Project: IEEE P802.15 Working Group for Wireless Personal Area Networks (WPANs)

Submission Title: [Proposal for TBDs in TVWS-NB-OFDM draft document]

Re: [Proposal of TVWS-NB-OFDM for IEEE 802.15.4m Document]

Abstract: [This document proposes additions and modifications of description of the TVWS-NB-OFDM section in the preliminary draft 15-12-0575-00-4m.]

20.3.3.1 Reference modulator diagram

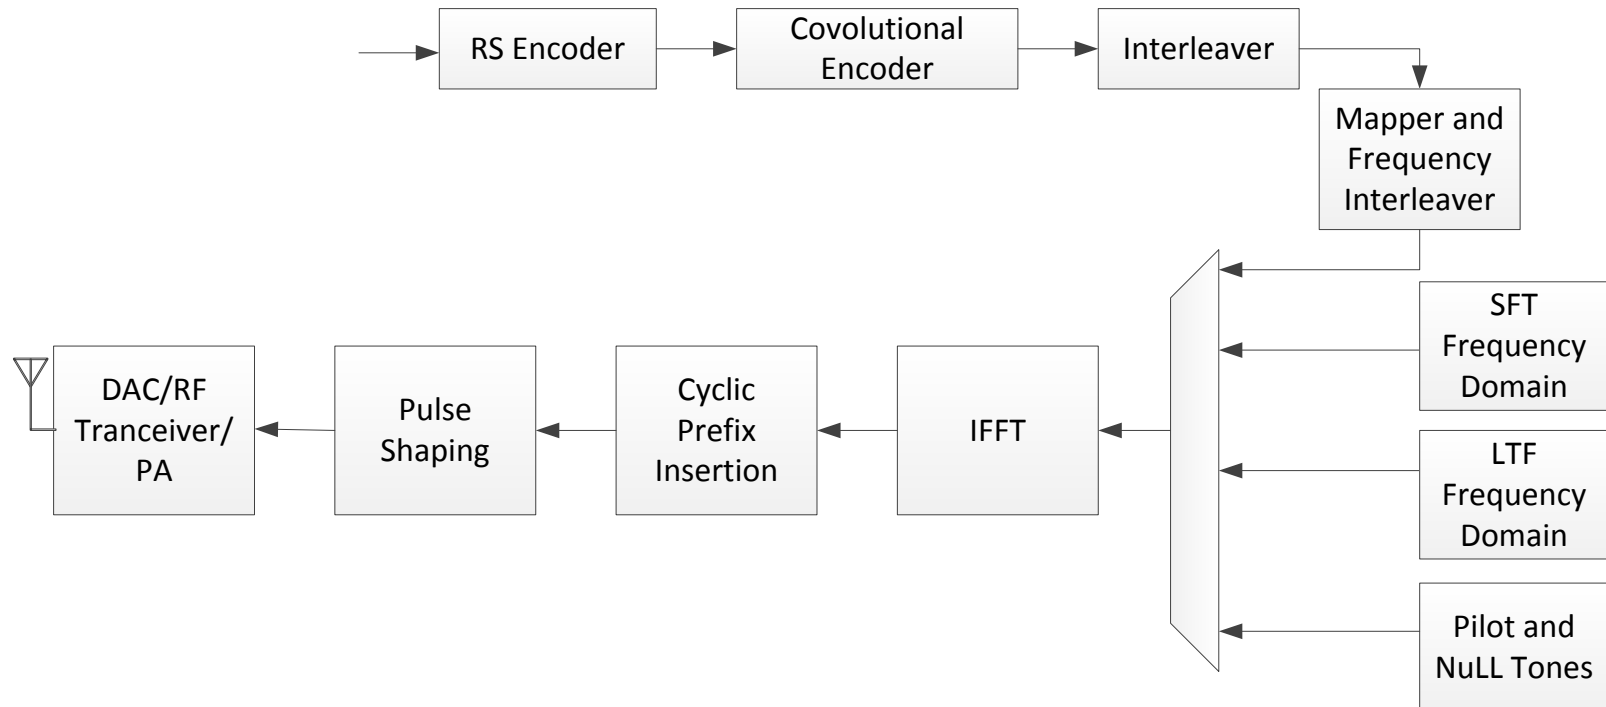
- The reference modulator diagram is shown in Figure zzz.

20.3.3.2.2 Inner encoding (1/2)

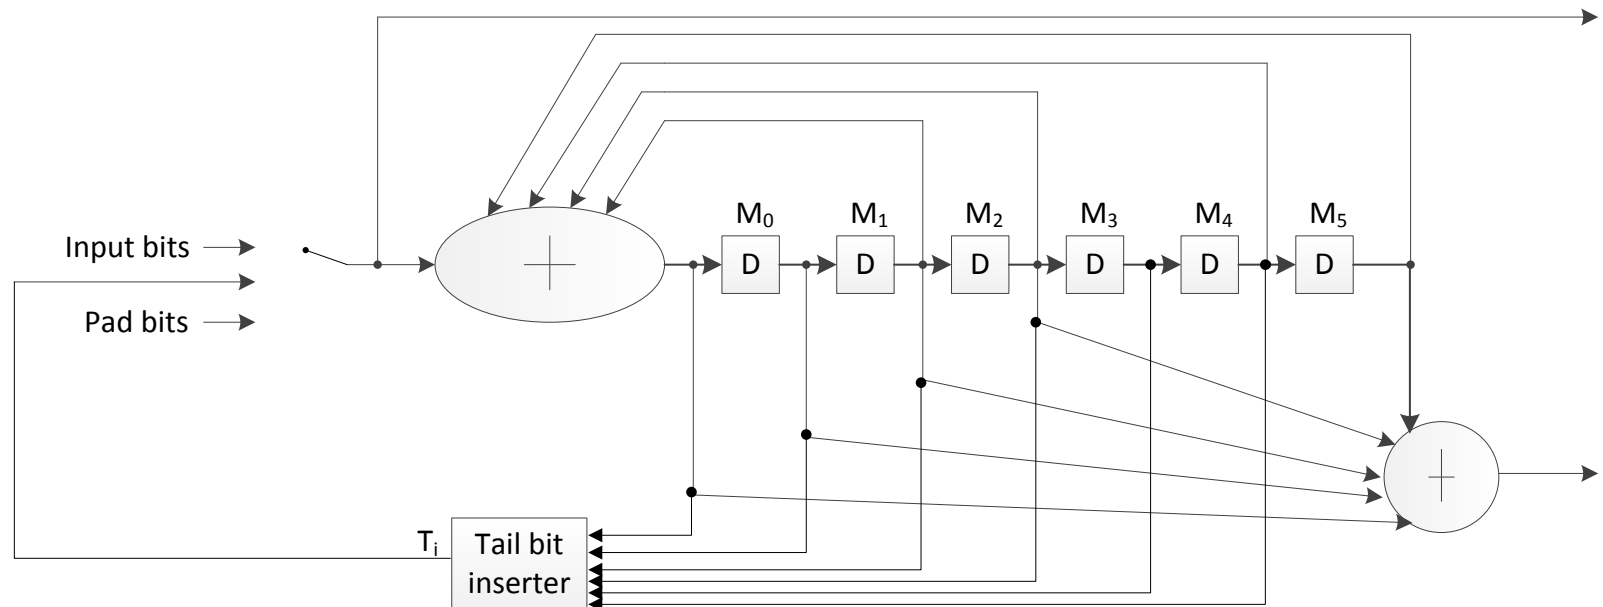
- A recursive and systematic convolutional encoder of coding rate $R = 1/2, 2/3, 3/4, 7/8$ encodes the RS encoded data bits, 6 tail bits, and pad bits. The convolutional encoder shall use the generator polynomials $g_0 = 171$ and $g_1 = 133$, of rate $R = 1/2$, with feedback connection of g_0 as shown in Figure 129.

- The value of the tail bits are dependent on the memory state shown in Figure 129 and shall be set as shown in Table xxx.
